January 23, 2007

SUBJECT: Assessment of Jim Howell's Proposed Concept
(Association of Oregon Rail and Transit Advocates)

Date: Jan. 2, 2007
To: Columbia River Crossing Task Force
From: Jim Howell
Subject: Response to Nov. 27, 2006 Memorandum from staff

SUBJECT: Jim Howell Proposal

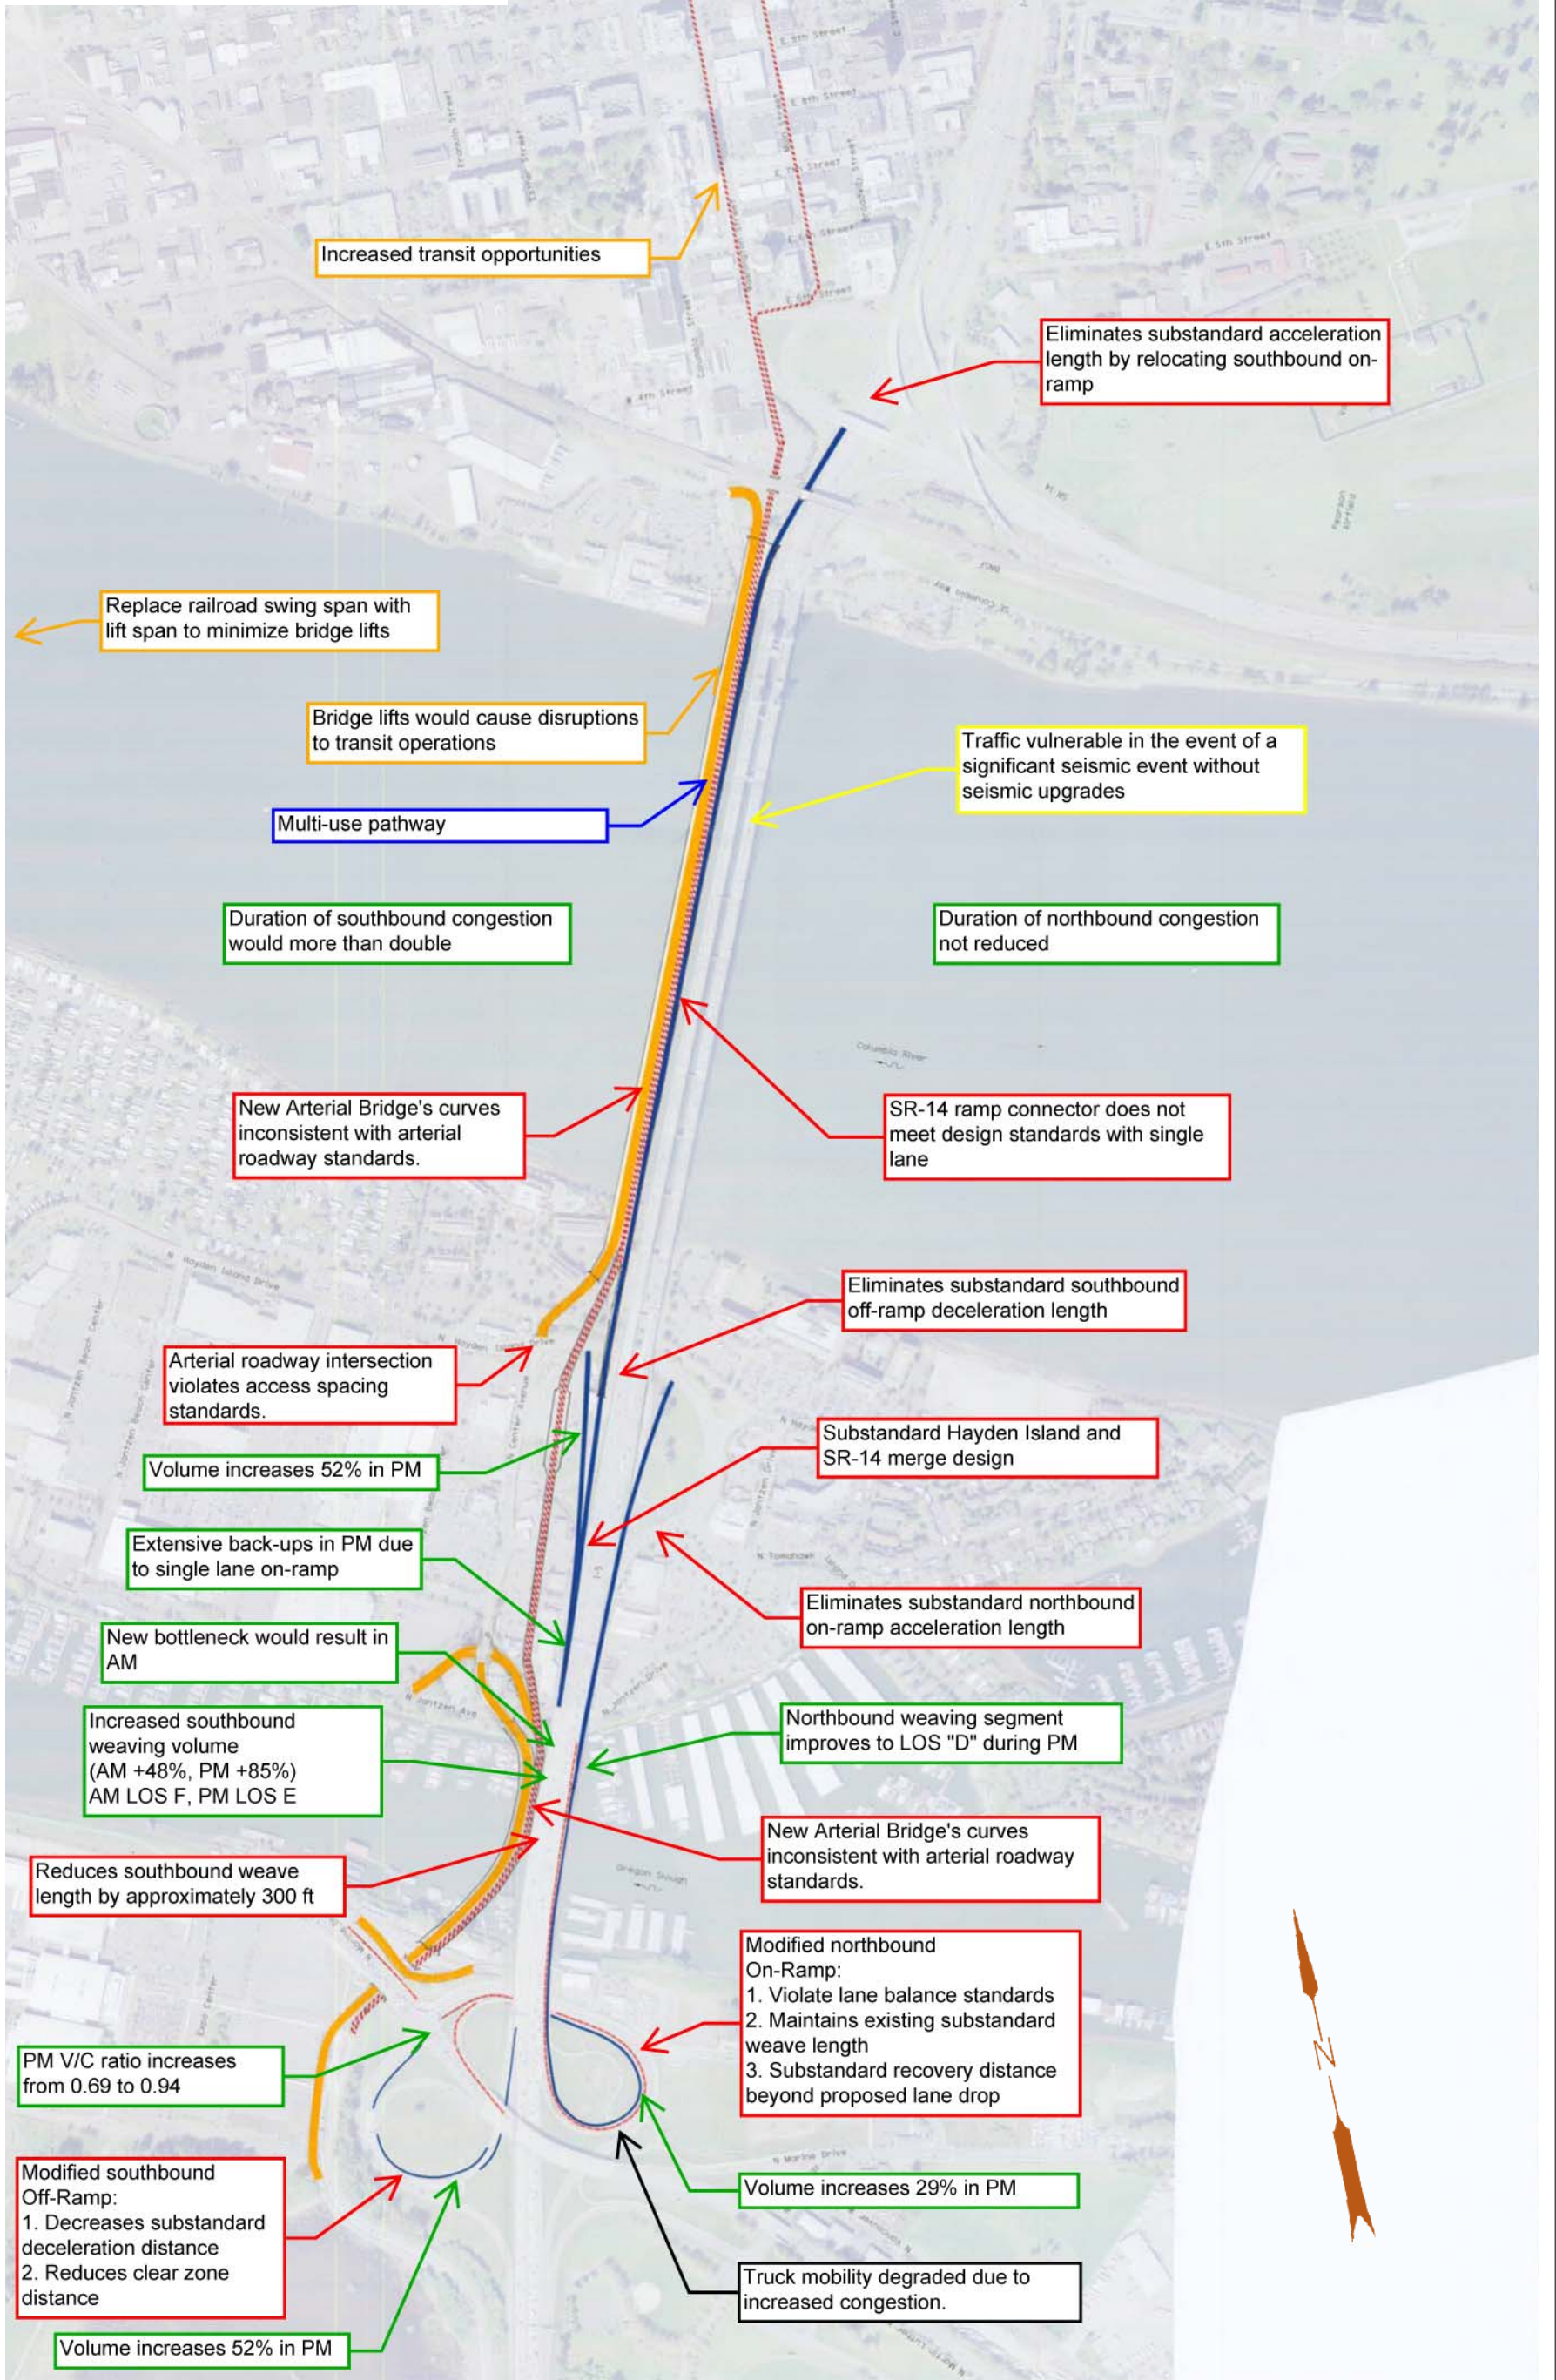
Attachments:

- AORTA's proposed concept with annotations illustrating key deficiencies
- Our memorandum to the CRC Task Force dated November 27, 2006
- I-5 Columbia River Crossing Statement of Purpose and Need

LEGEND:

- Growing travel demand and congestion
- Impaired freight movement
- Limited public transit operation, connectivity, and reliability
- Safety and vulnerability to incidents
- Substandard bicycle and pedestrian facilities
- Seismic vulnerability

**MULTI-MODAL BRIDGE OPTION
(ARTERIAL - LIGHT RAIL - BIKE/PED.
AND ON-RAMP EXTENSION)**

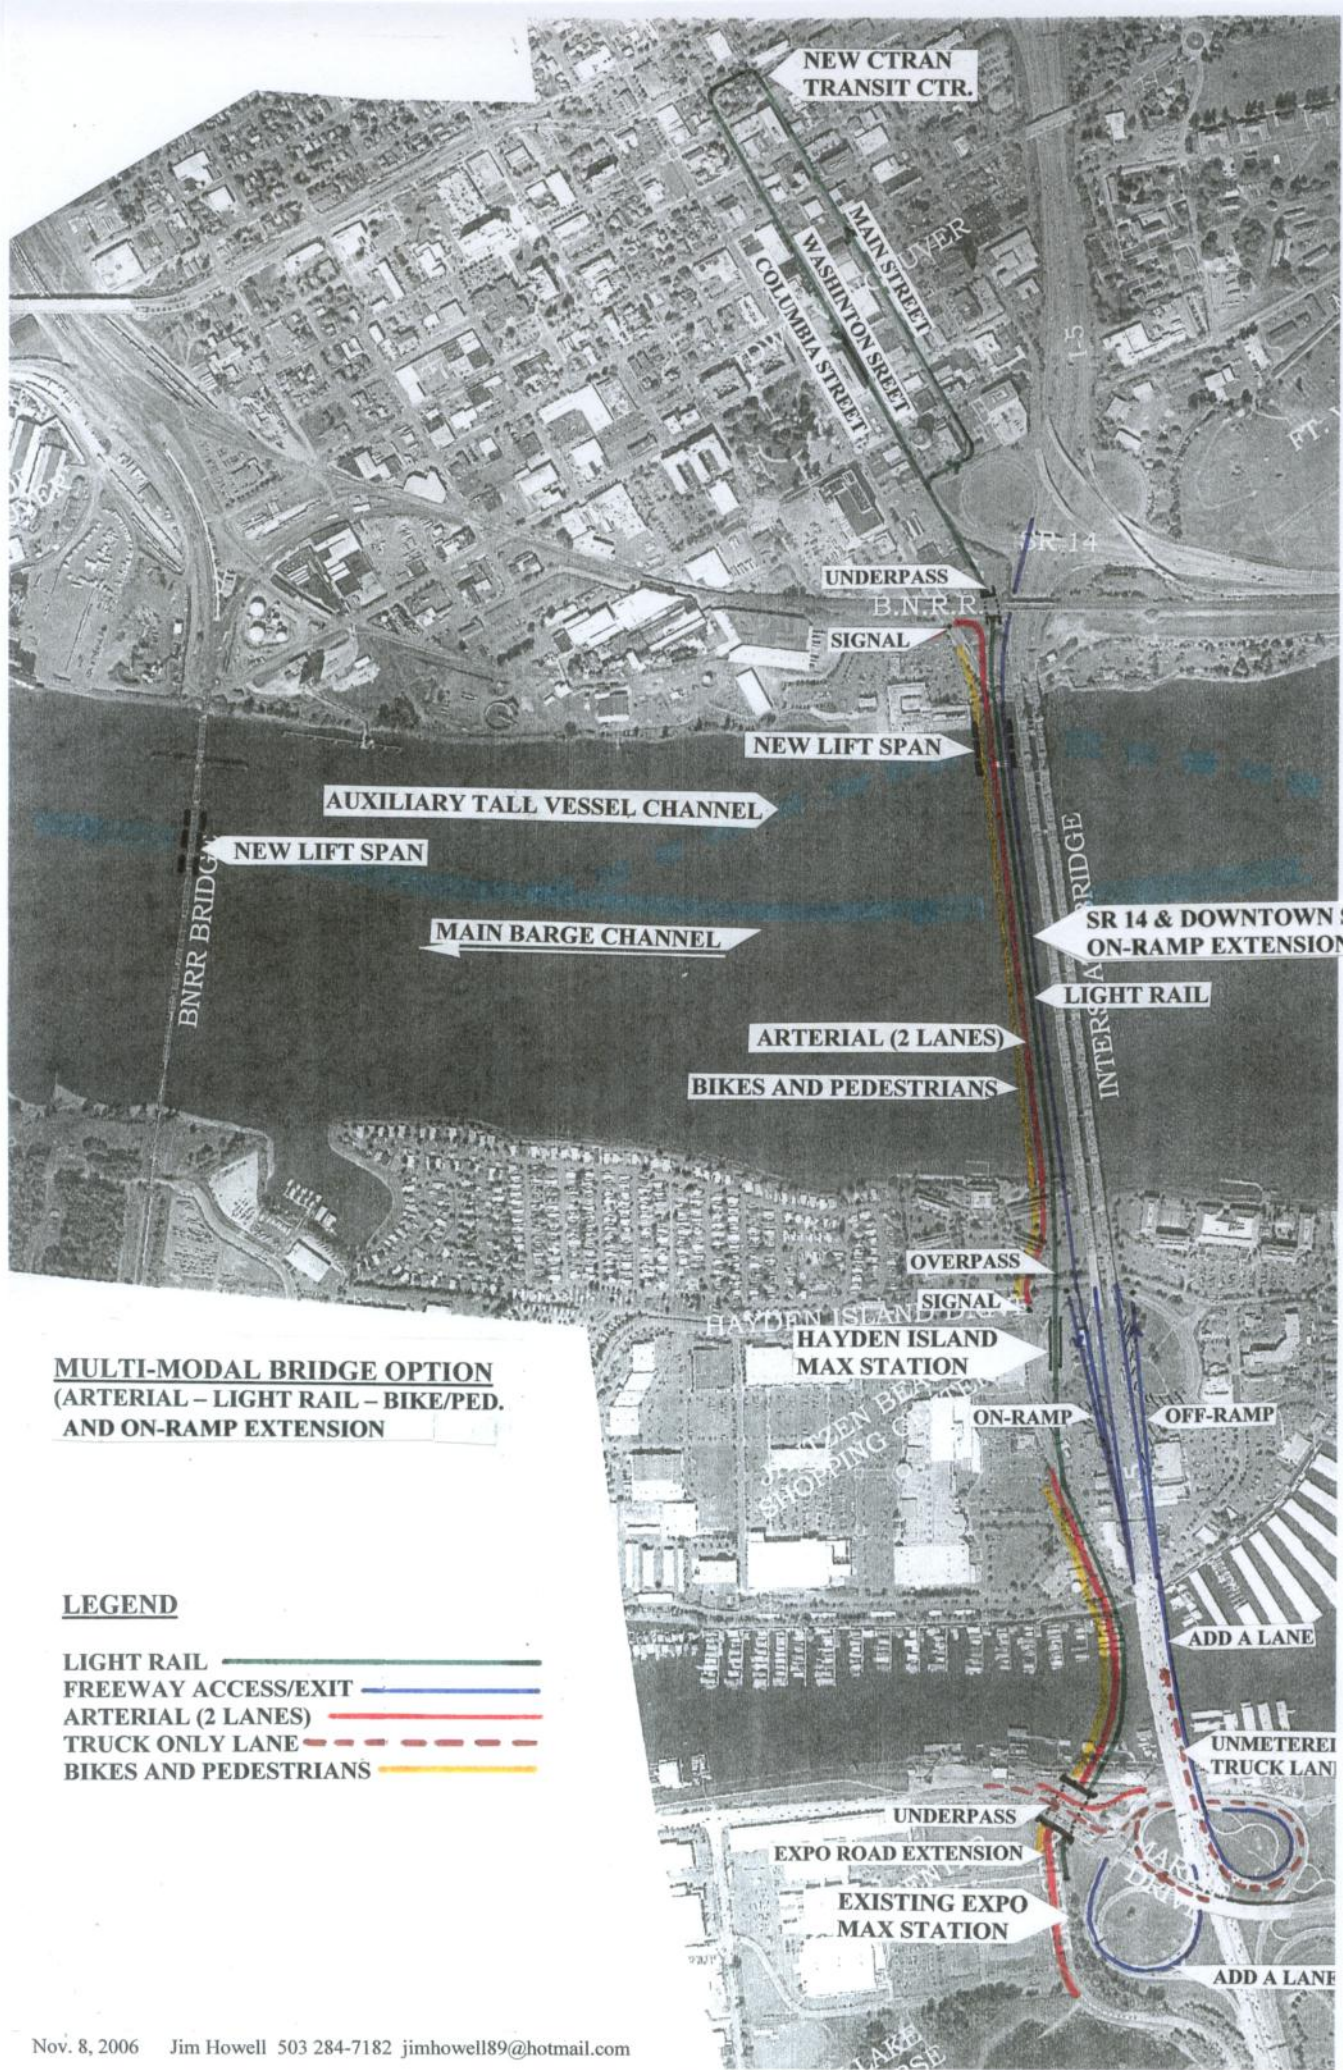
The following 11 new or worsened substandard design and safety features would result under the proposed concept:

- Relocation of SR 14's westbound on-ramp to southbound I-5, with Hayden Island on-ramp:

- This action would reduce the existing substandard weaving length between Hayden Island and Marine Drive by approximately 300 feet.
- It would introduce a substandard length between the new Hayden Island and SR 14 merge point and the combined merge with southbound I-5. The proposed distance is 450 feet but the minimum standard for successive on-ramps is 800 feet.

- The SR 14/Downtown Vancouver connector ramp, proposed to provide one-lane, should be two lanes to meet design guidelines for its length.
- Modification of Marine Drive's off-ramp from southbound I-5:

- This action would decrease the existing substandard deceleration distance by approximately 435 feet.
 - It would reduce the clear zone distance between the traveled way and the west abutment of the Marine Drive overpass.

- Modification of Marine Drive's on-ramp to northbound I-5:
 - This action would violate lane balance standards needed to provide continuity in traffic flow.

- Maintains the existing substandard weaving length, but when additional lanes are added as proposed, design standards require extending the weaving length.

- Results in substandard recovery distance beyond the proposed lane drop.
- Provision of new arterial roadway across the North Portland Harbor:
 - The roadway curves shown on the proposed concept would enable a 20 mph design speed, likely translating into a roadway with a 15 mph posted speed. This is inconsistent with arterial roadway standards.

- Provision of a new arterial roadway across the Columbia River:
 - The roadway curves proposed on the proposed concept would enable a 20 mph design speed, likely translating into a roadway with a 15 mph posted speed. This is inconsistent with arterial roadway standards.

- The intersection of the arterial roadway with North Hayden Island Drive would be located about 250 feet west of the relocated ramp terminal to southbound I-5. This violates minimum design standards that require at least 1,320 feet between ramp terminals and adjacent intersections.
